Project	<b>IEEE 802.16 Broadband Wireless Access Working Group</b> < <a href="http://ieee802.org/16">http://ieee802.org/16</a> >	
Title	Corrections to Figure 67	
Date Submitted	<b>2005-06-25</b>	
Source(s)	Lei Wang, Adam Newham Cygnus Multimedia Communications, Inc.	Voice (760)448-1984 Fax: (760)448-1989  <a href="mailto:lwang@cygnuscom.com">Email: lwang@cygnuscom.com</a>
Re:	This is a contribution to IEEE 802.16 Cor1.	
Abstract	The timer T9 shall be stopped at BS after receiving SBC-REQ from the SS during network entry, because it is the allowed time between the BS sending RNG-RSP (success) to a SS and receiving a SBC-REQ from the same SS.	
Purpose	To correct Figure 67.	
Notice	This document has been prepared to assist IEEE 802.16. It is offered as a basis for discussion and is not binding on the contributing individual(s) or organization(s). The material in this document is subject to change in form and content after further study. The contributor(s) reserve(s) the right to add, amend or withdraw material contained herein.

## Corrections to Figure 67

**Figure 87 CDMA Initial Ranging -- BS**

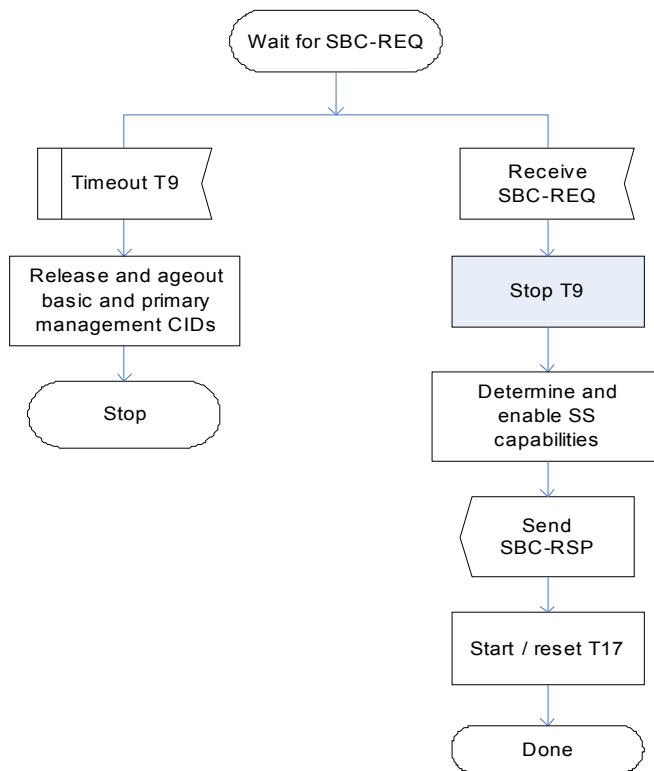
The timer T9 shall be stopped at BS after receiving SBC-REQ from the SS during network entry, because it is the allowed time between the BS sending RNG-RSP (success) to a SS and receiving a SBC-REQ from the same SS. However, in Figure 67 of IEEE Std 802.16-2004, the timer T9 was not stopped after receiving the SBC-REQ. This contribution provides a modified Figure 67 to correct this problem.

*Replace Figure 67 with the following figure:*
